RE: 140 Arroyo Grande Way

I reviewed the drawings, and evaluated the site context. My comments and recommendations on the design are as follows:

NEW STREET VIEW

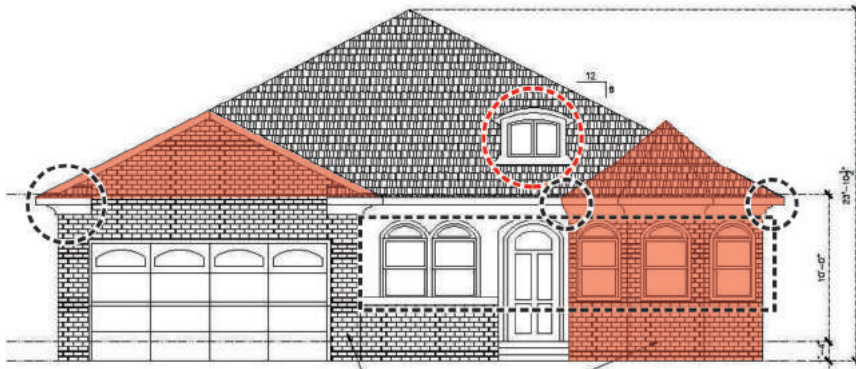
Garage front wall height and tall eaves and ridge heights are out of scale with the immediate neighborhood

1. The tall floor to eave height and roof ridge height are out of scale with the immediate neighborhood.
2. The front elevation has too many elements fighting for attention.

Too many elements fighting for attention

- Tall gable end
- Roof dormer unrelated to the architectural style
- Complex bay window and roof form
- Arched windows
- Large stone masses
- Gable returns unrelated to the architectural style

1. Lower the roof eave height as much as possible. The recommendation illustrations show a one foot decrease in height.
2. Utilize a hip roof on the garage in lieu of the proposed gable.
3. Simplify the window forms and styles and provide wood trim on all facades.
4. Eliminate the brick in favor of a uniform stucco treatment, and add a moulding trim strip.
5. Substantially recess the garage door, and select a garage door color to blend with the main body of the home rather than contrasting with it.
6. Remove the roof dormer to simplify the roof.

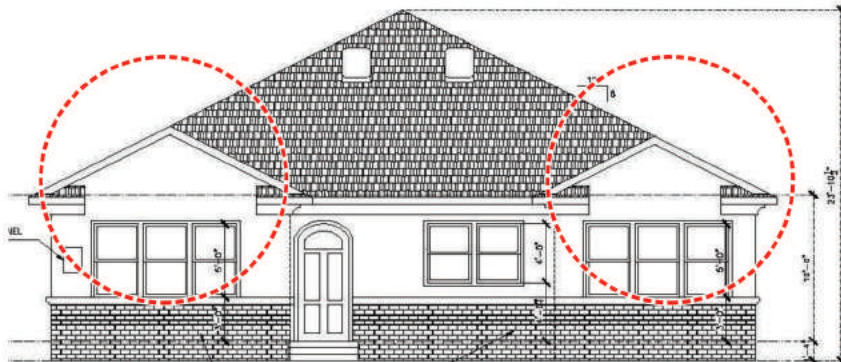
3. The gables on the rear elevation are very awkward, and unrelated to the architectural style.

Awkward gables unrelated to the roof form or architectural style

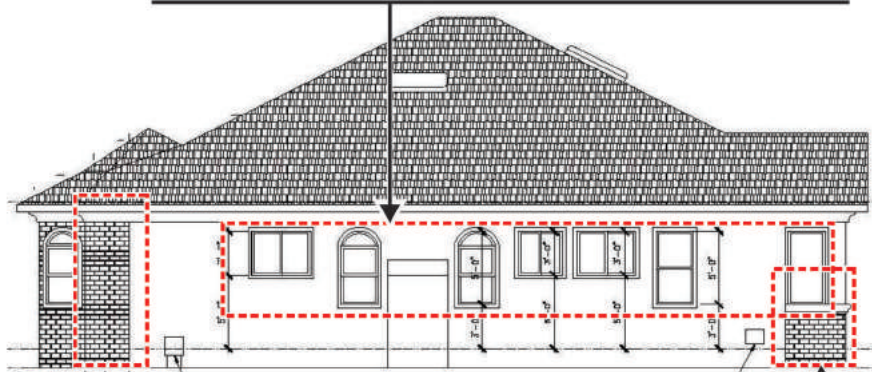
4. Wrapping the brick around on the side elevation and then stopping it in the same plane as the stucco wall is not consistent with Residential Design Guidelines 3.2.2 and 3.8.4.

Multiple window style and proportions is not consistent with Residential Design Guideline 3.7.2 and 3.7.4

Wrapping brick around corners and then stopping is not consistent with Residential Design Guideline 3.2.2

The illustration below shows the streetscape with the recommended front elevation.

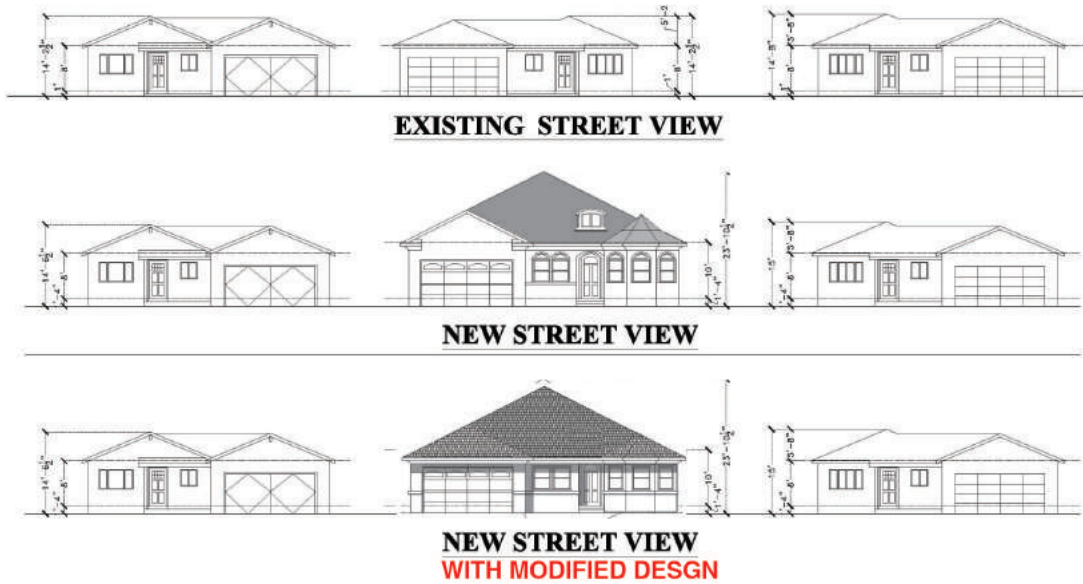
While the front elevation drawing still appears rather tall, in reality the slope of the roof will substantially mitigate that effect - see example photo below
